**Global Energy Nigg Ltd – Marine License MS-00009032 (Quay Construction)
Request for a Screening Opinion**

Enc: Nigg East Quay (Marine License MS-00009032 (Construction) – Request for a Screening opinion

NIGG EAST QUAY (MARINE LICENSE MS-00009032 (CONSTRUCTION) – REQUEST FOR A SCREENING OPINION

PROJECT:
STAGE F
CAPITAL DREDGE CUT AND FILL
ANALYSIS
DRAWN: DPS
PROJECT MANAGER: PM
CHECKED: IF
DATE: 17/01/22
SCALE: 1:500
SHEET: A1
TOTAL SHEETS: 54
PROJECT NO: P02
DOCUMENT REFERENCE NUMBER: SL08904-HBPW-00-ZZ-DR-C-0078

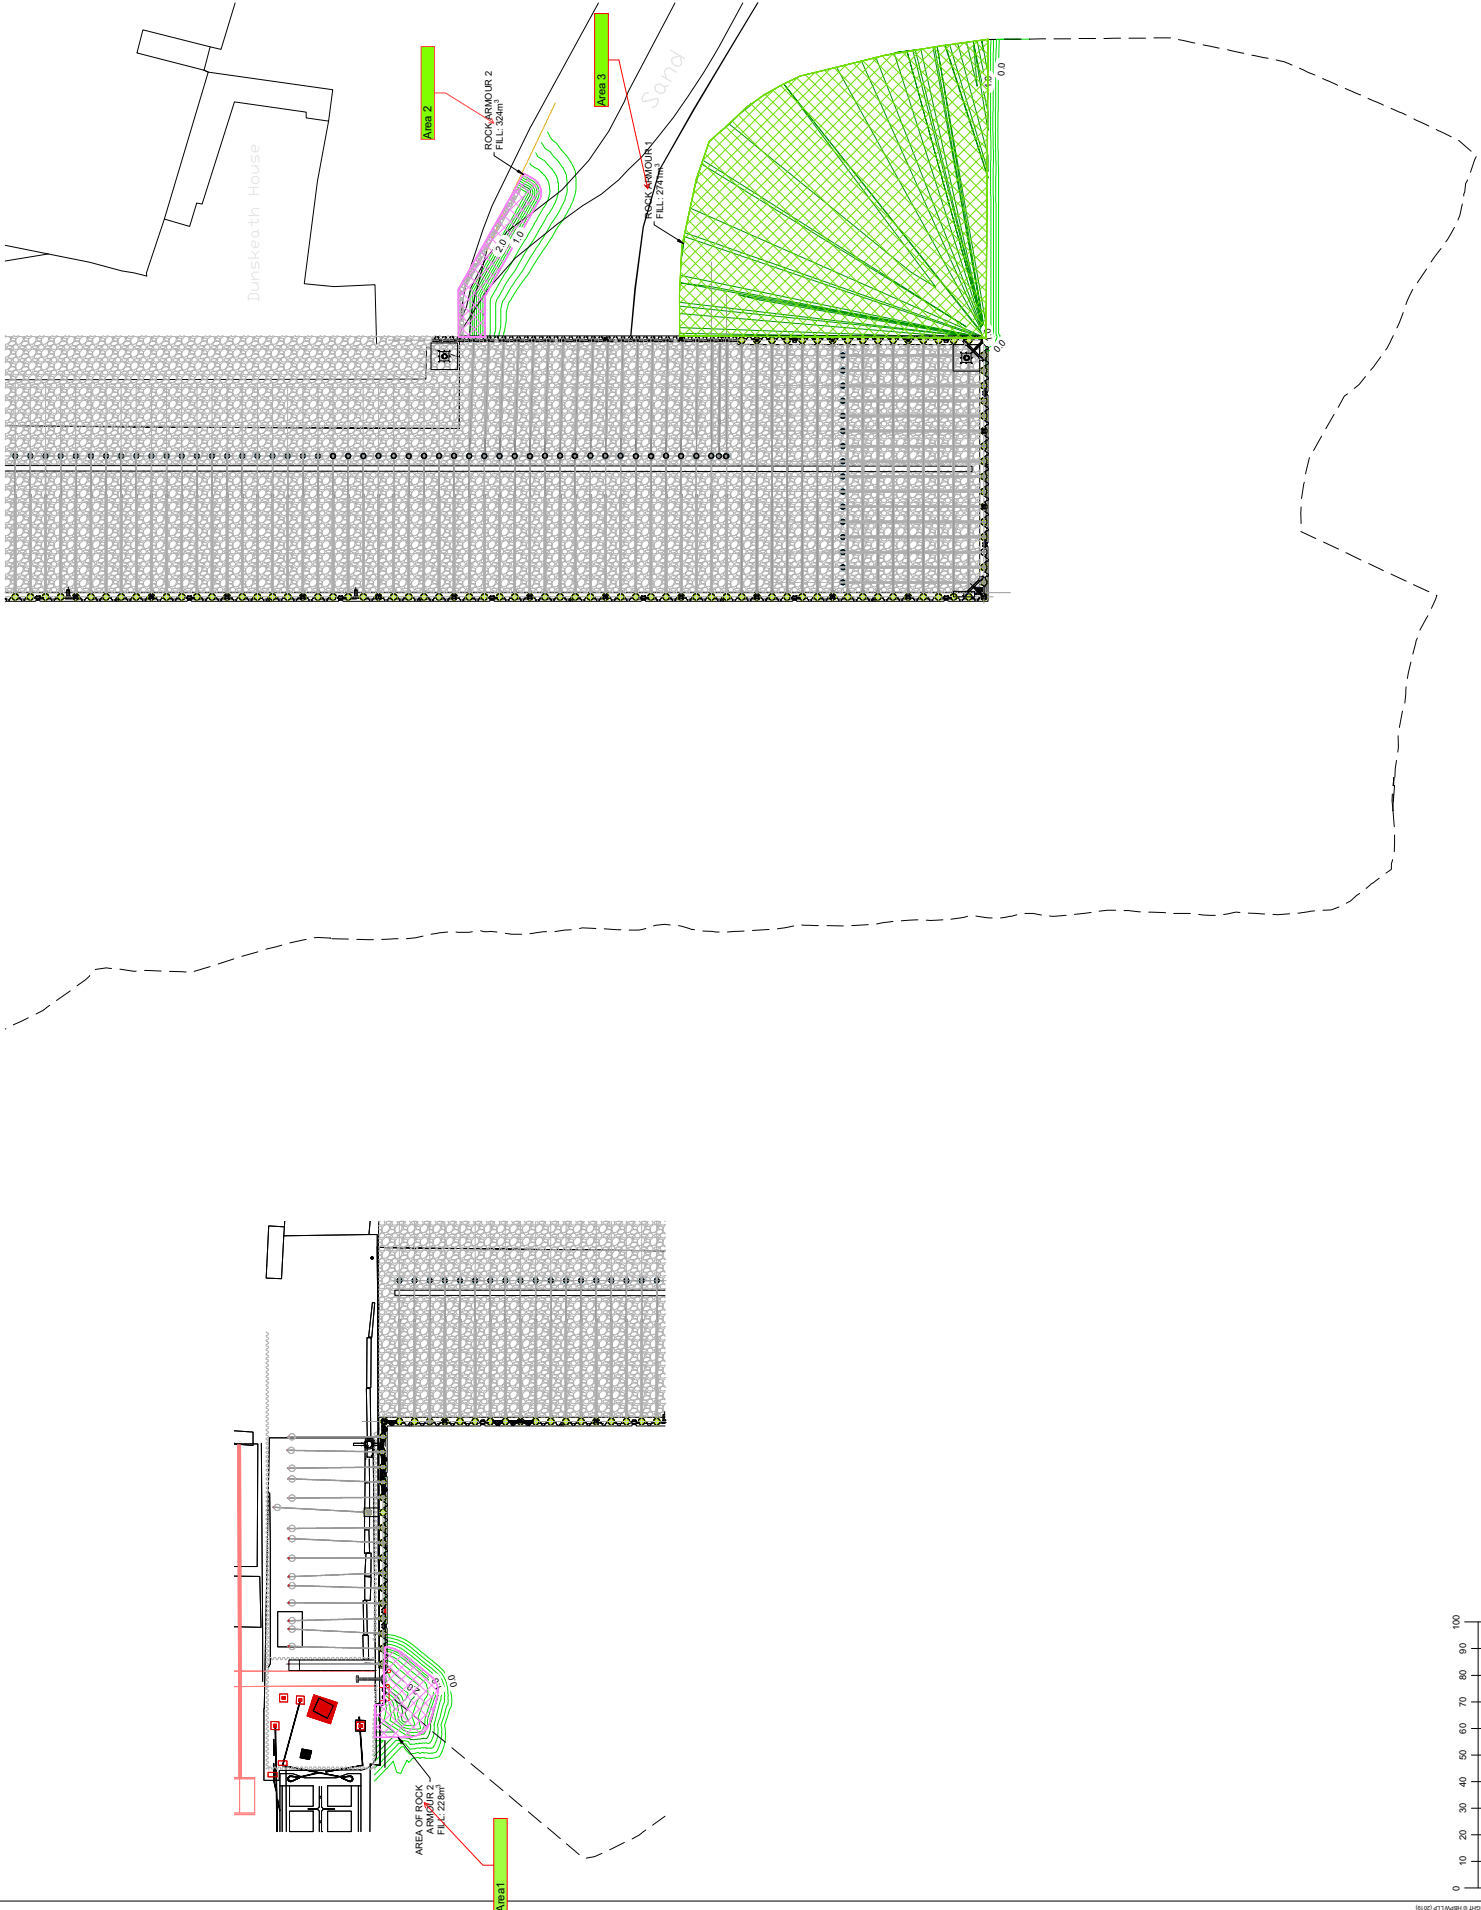
The proposed amendment to the marine license is to include a maximum quantity of 8,830 tonnes (~3,293 m³) of rock armour onto the list of licensed material authorised under Condition 2.4 of the license.

The incorporation of the rock armour into the development design is intended to provide long-term stability to the final dredge slope design as well as minimise maintenance requirements. There are three areas in which the rock armour will be placed as detailed below and shown on Drawing No SL06904-HBPW-))-ZZ-DR-C-0078, Appendix A.

Area 1

For operational reasons, the berthing footprint on the western side of the quay requires a depth of -12m CD. The existing piles at the East Roundhead have a toe level of -9m CD. As a result, the removal of sediment through dredging cannot go deeper at this point due to stability concerns relating to the existing East Roundhead. To accommodate a steeper slope to minimise infringement on the berthing footprint and prevent collapse of the East Roundhead, it is proposed to place circa 611 tonnes (~228 m³) of Type 2 rock armour to face the slope over an area of 0.04 Ha (400 m²).

Area 2

The concern in relation to Area 3 is the existing gabion wall being undermined due to scouring action. On the east side of the quay, approximately 869 tonnes (~324 m³) of Type 2 rock armour is required over an area of 0.05 Ha (500 m²) to reduce the effect of scouring in this area.

Area 3

It is proposed to place circa 7,350 tonnes (~2,741 m³) of Type 1 rock armour over an area of 0.35 Ha (3,500 m²) to stabilise the dredge slope up from the final dredge level.
